# Access Compliance Report

## Public Rights-of-Way

Intersection ID: 10037289	Main Street: SARDIS_RD_NORTH	Cross Street: N/A	Location: SE
ADA ID: AAFFC3669BD5	Ramp Type: Perp	Initial Pass/Fail: Fail	Overall Compliance: No
Codes/Mitigation Info/Possible Solution		Field Measurements/Component Compliance	
Severity Score: 12.5

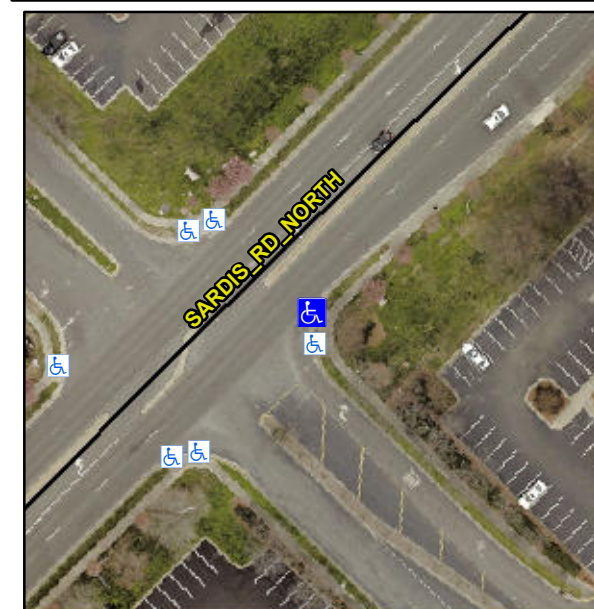
**Not Found, R304.2.2**

Compliance	Description	Data	Compliance	Description	Data
N/A	Ramp Length (in)	60.0	No	Ramp Slope (%)	9.8
Yes	Ramp Width (in)	48.0	Yes	Ramp XSlope (%)	0.4
N/A	Flare Type LT	N/A	N/A	Flare Type RT	N/A
N/A	Flare Slope LT (%)	N/A	N/A	Flare Slope RT (%)	N/A
N/A	Flare Traversable LT?	N/A	N/A	Flare Traversable RT?	N/A
N/A	Landing Length (in)	N/A	N/A	DWS Provided?	N/A
N/A	Landing Width (in)	N/A	N/A	DWS Contrast?	N/A
N/A	Landing Slope (%)	N/A	N/A	DWS Length (in)	N/A
N/A	Landing X Slope (%)	N/A	N/A	DWS Full Width?	N/A
N/A	Landing Curb? (Y/N)	N/A	N/A	DWS Offset (in)	N/A
N/A	Shared Landing?	N/A			
N/A	Gutter Ponding?	N/A	N/A	Gutter Slope (%)	N/A
N/A	Gutter Lip Ht (in)	N/A	N/A	Gutter X Slope (%)	N/A
N/A	Painted X Walk1?	No	N/A	Painted X Walk2?	N/A
	X Walk 1 Direction	To NW		X Walk 2 Direction	N/A
N/A	X Walk 1 Width (in)	N/A	N/A	X Walk 2 Width (in)	N/A
	X Walk 1 Slope (%)	0.4		X Walk 2 Slope (%)	N/A
	X Walk 1 X Slope (%)	0.8		X Walk 2 X Slope (%)	N/A

**Remove & Replace Entire Ramp.**
